Von Buskirk

B1801650

445 15th Street SE,
Washington DC 20003

District of Columbia
CASE NO. 19747

Roof Frame

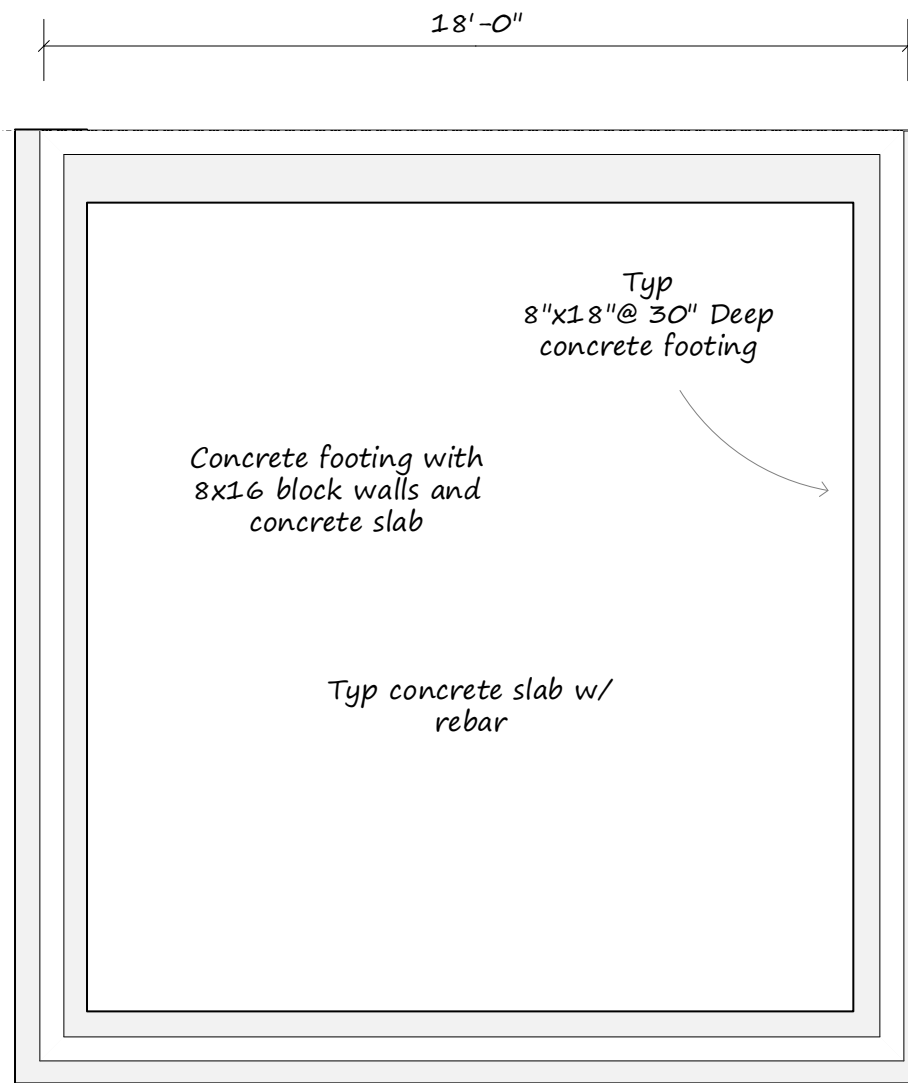
Fix over span rafters by adding sisters

Rafters over span 14'2" max
Add rafters to side

Typ. Slab detail

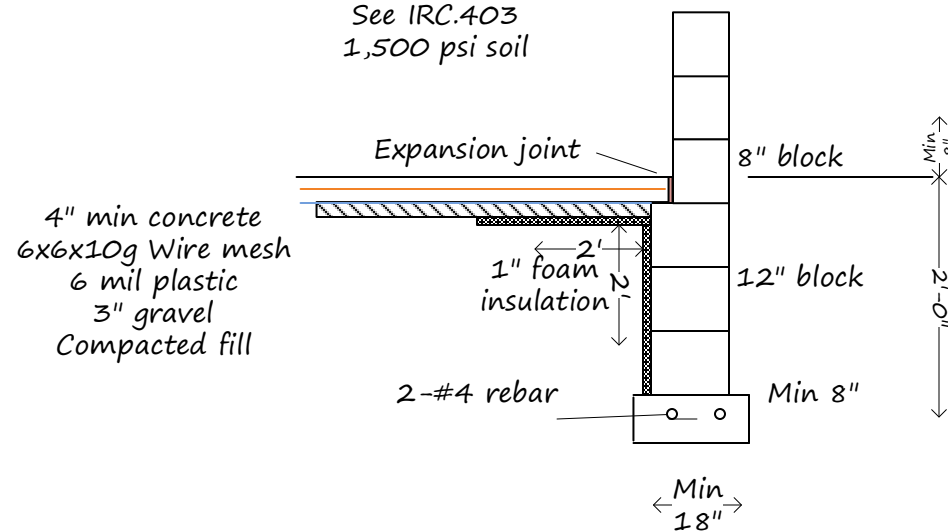
See IRC.403
1,500 psi soil
